**Final submission from
Lynn Jones**

Application from the CNL to amend its Chalk River Laboratories site licence to authorize the construction of a near surface disposal facility

**Commission Public Hearing
Part 2**

Final Submission with respect to Canadian Nuclear Laboratories' application to amend its Chalk River Laboratories site licence to authorize the construction of a "near surface disposal facility"

Figure 8-7 Percent Contribution by Radionuclide for Predicted Dose to an Infant in Pembroke (Bathtub Scenario)

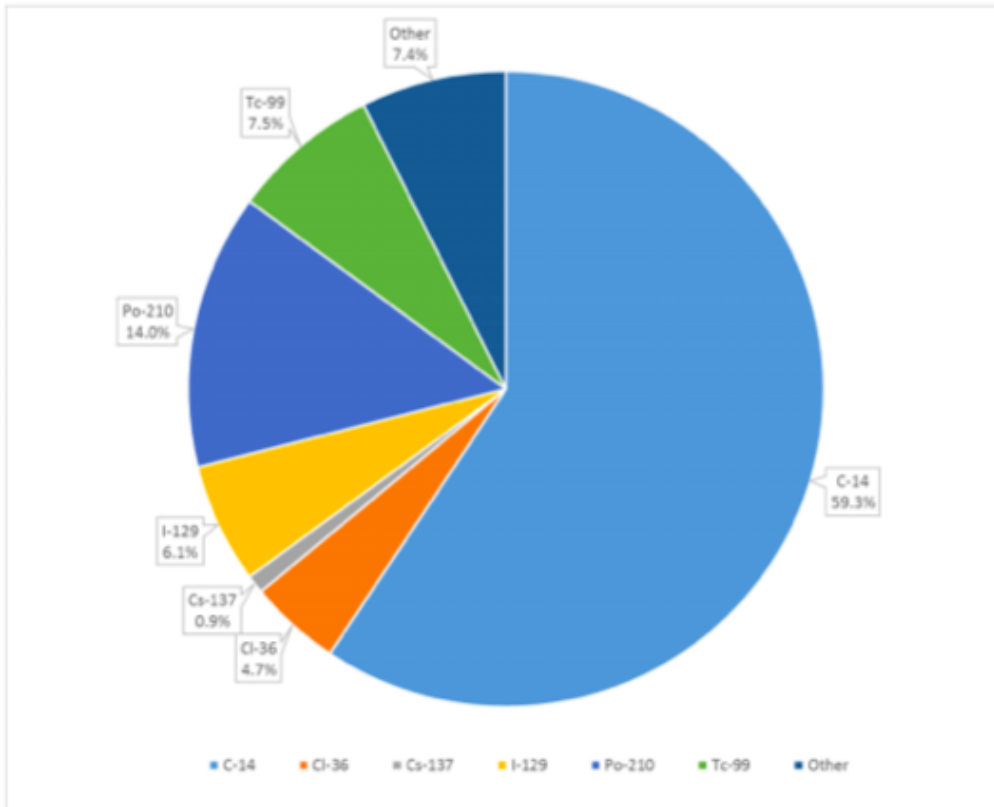
And finally here is a pie chart showing the contribution of various radionuclides (such as Carbon-14, Polonium and Caesium-137) to the radiation dose that would be received by an infant downstream in Pembroke, under the “bathtub scenario” of “normal evolution” of the Chalk River Mound: (Page 190 of the Performance Assessment document)

So again, **clearly the proposed NSDF will not contain and isolate wastes from the biosphere.** And again, every release of radioactive material into the Ottawa River increases risks of adverse effects (cancer, birth defects and genetic mutations) in human and non-human biota from exposures to radiation. These increased risks, especially the ones occurring in the distant future cannot be justified (and therefore are not “reasonable”) because the people being exposed the them would have received **zero benefit** from the nuclear programs that produced the wastes and risks.

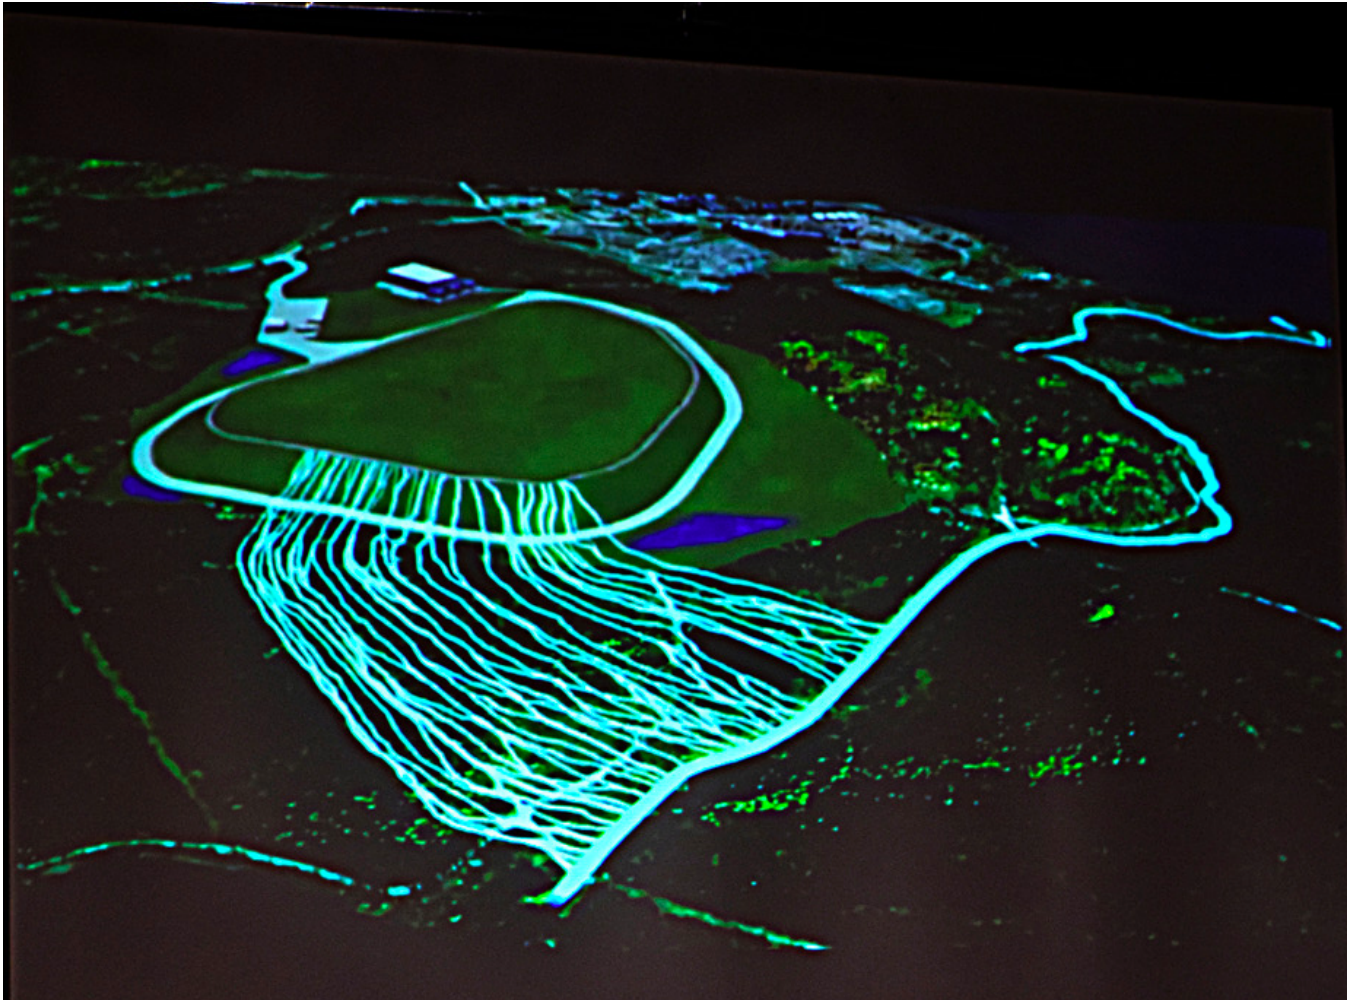
The graphic below was produced by Radio Canada “Découverte” in March 2018 for its superlative documentary, Chalk River Heritage. The graphic shows the mound overflowing and radioactively contaminated material spilling out of the

mound and entering the Ottawa River under the “bathtub scenario” described by the proponent as one of two likely scenarios for “normal evolution” of the mound.
